**COUNTY OF SAN MATEO
PLANNING AND BUILDING DEPARTMENT**

SUBJECT: EXCECUTIVE SUMMARY: Consideration of a Design Review Permit, Coastal Development Permit, Non-Conforming Use Permit, and Off-Street Parking Exception to allow construction of a new 1,438 sq. ft., three-story, single-family residence with an attached 197 square foot, one-car garage on a 3,408 square foot legal, developed parcel (COC95-0001), at 2006 Vallemar Street in the County unincorporated area of Moss Beach. Due to the non-conforming size and triangular shape of the parcel, the applicant requests an Off-Street Parking Exception to allow one covered parking space where two covered spaces are required, as well as a Non-Conforming Use Permit to allow a 12-foot combined side setback where 15 feet is required, and a front setback of 17 feet where 20 feet is required. No tree removal and minor grading is proposed. The project is appealable to the California Coastal Commission.

County File Number: PLN 2020-00450 (Parsey)

SUBJECT: Consideration of a Design Review Permit, Coastal Development Permit, Non-Conforming Use Permit, and Off-Street Parking Exception, pursuant to Sections 6565.3, 6328.4, 6133.3, and 6120 of the

Sheet No.
 A-2

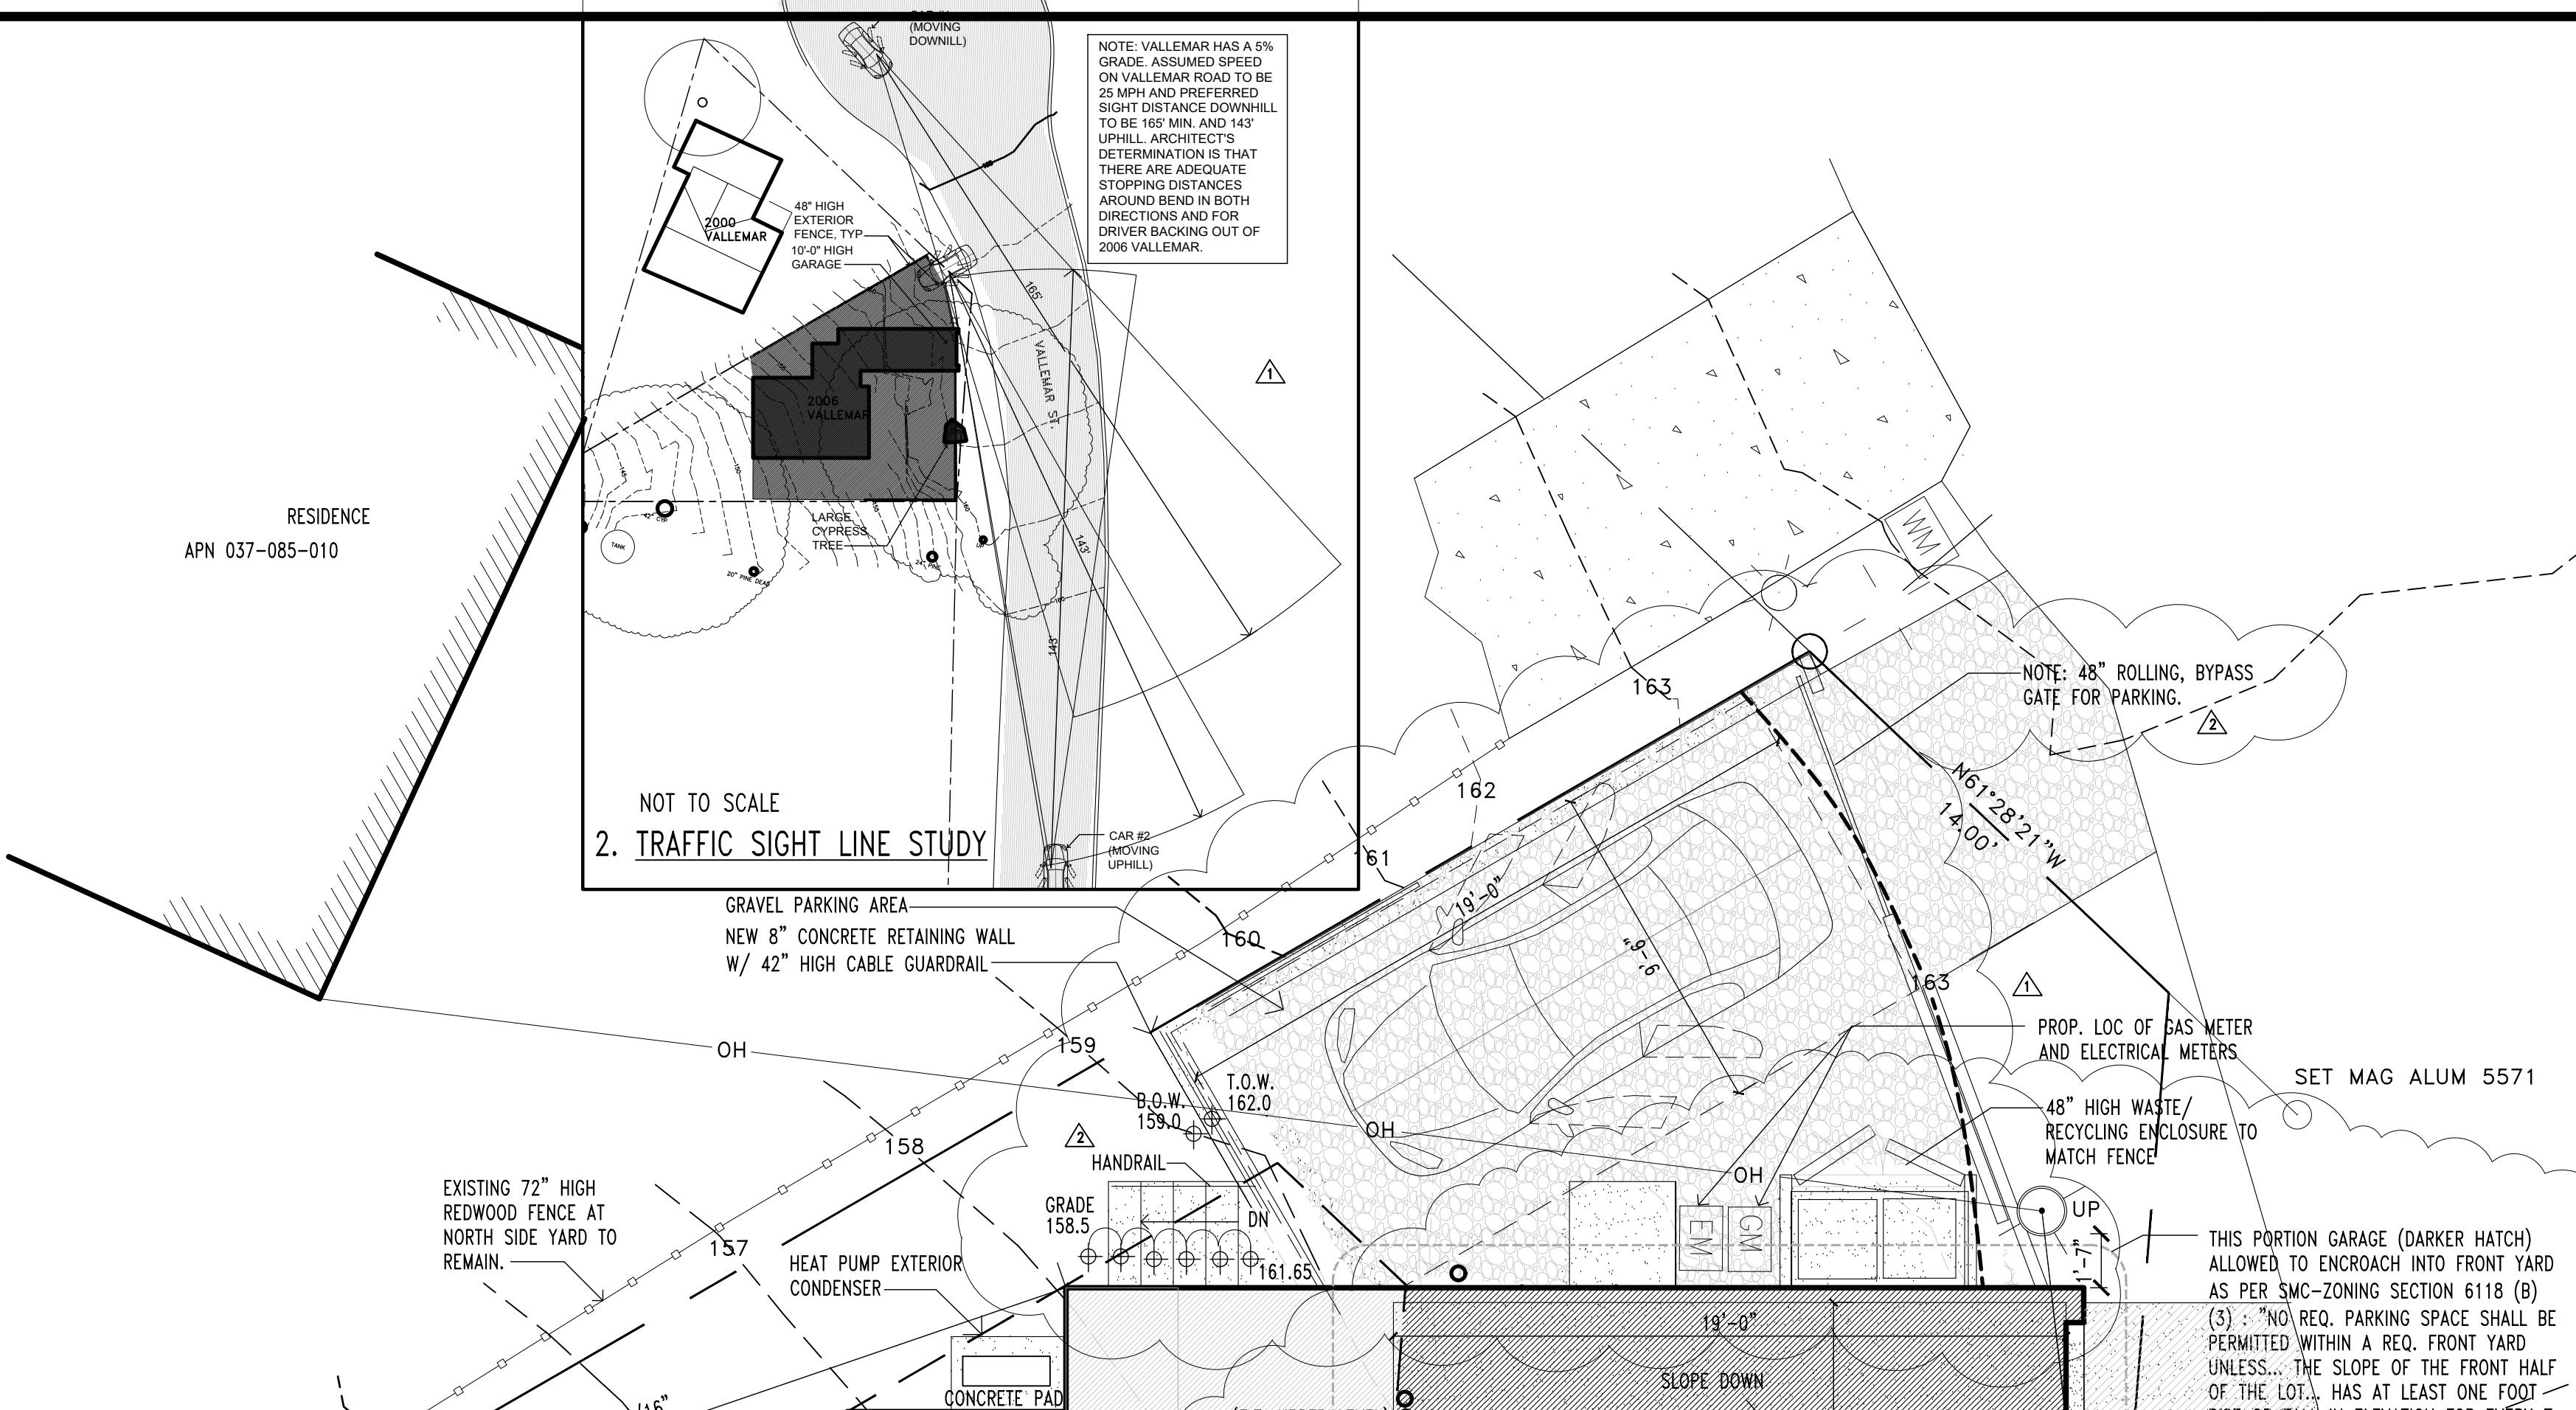
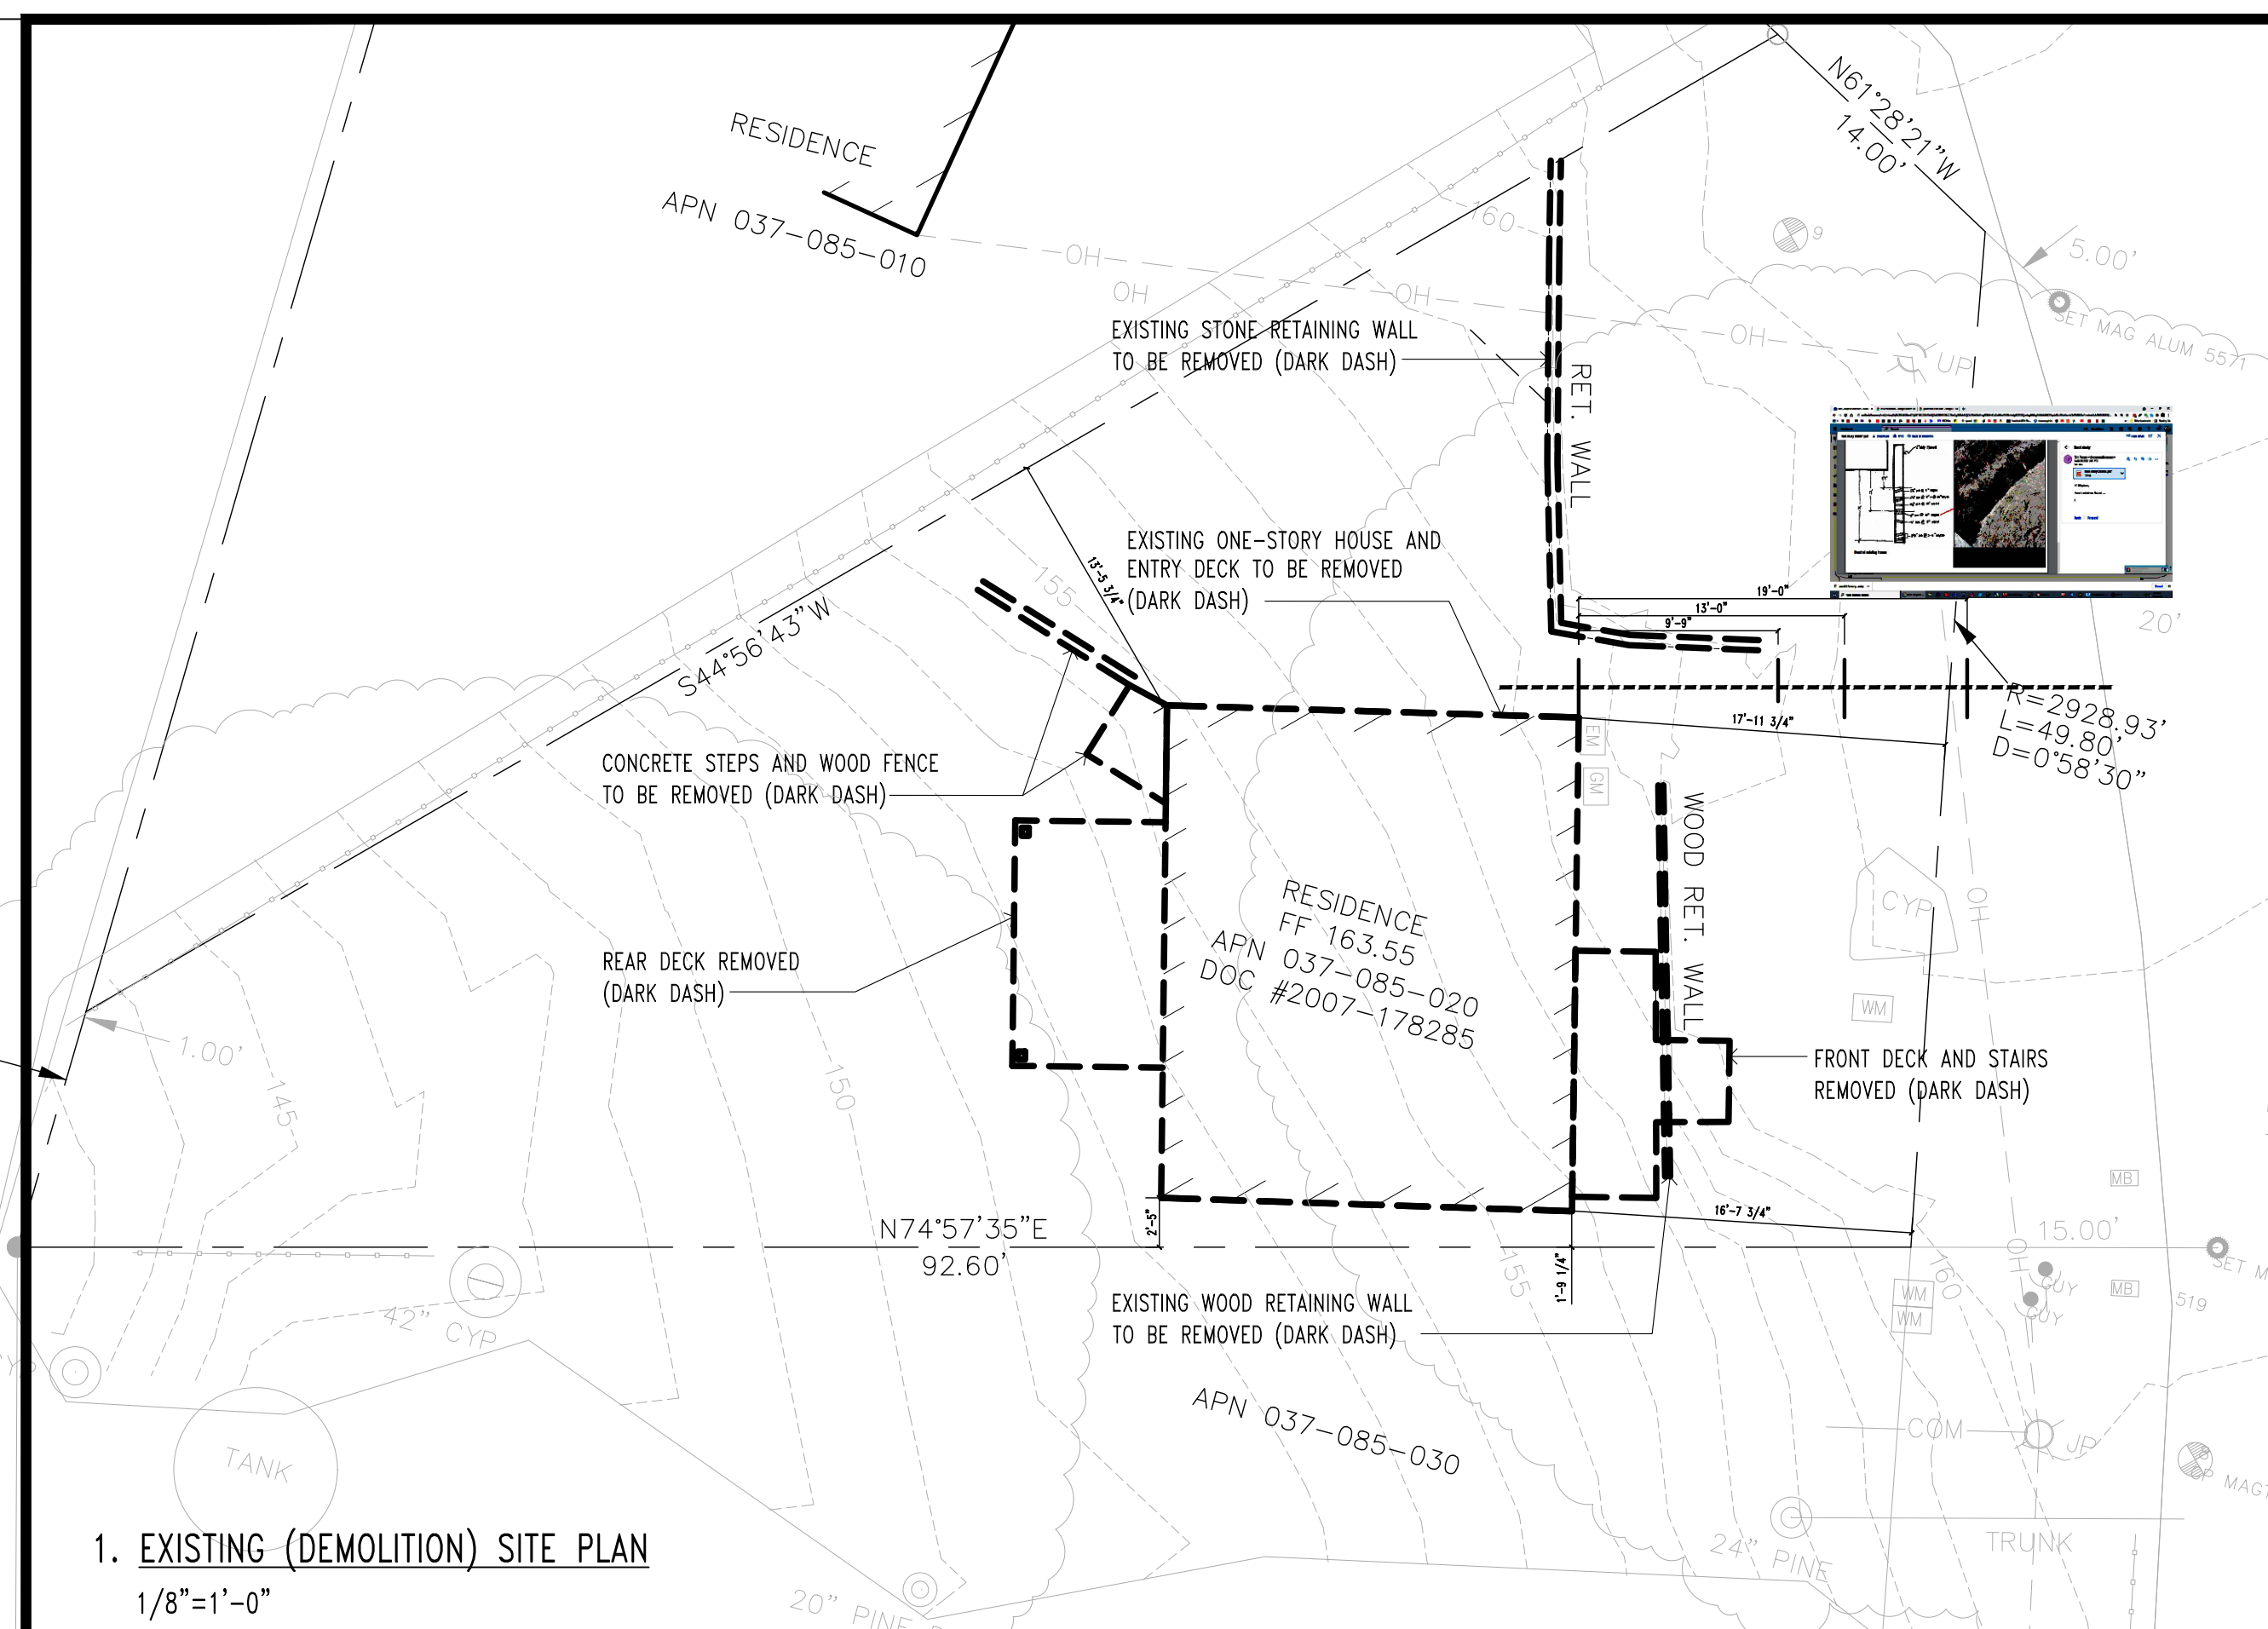
36. On building plans submitted for the Building Permit Application for the new residence, please remove the proposed swing gate shown on Page A-2. Gates cannot swing out into the public right-of-way. A sliding gate on private property may be used.
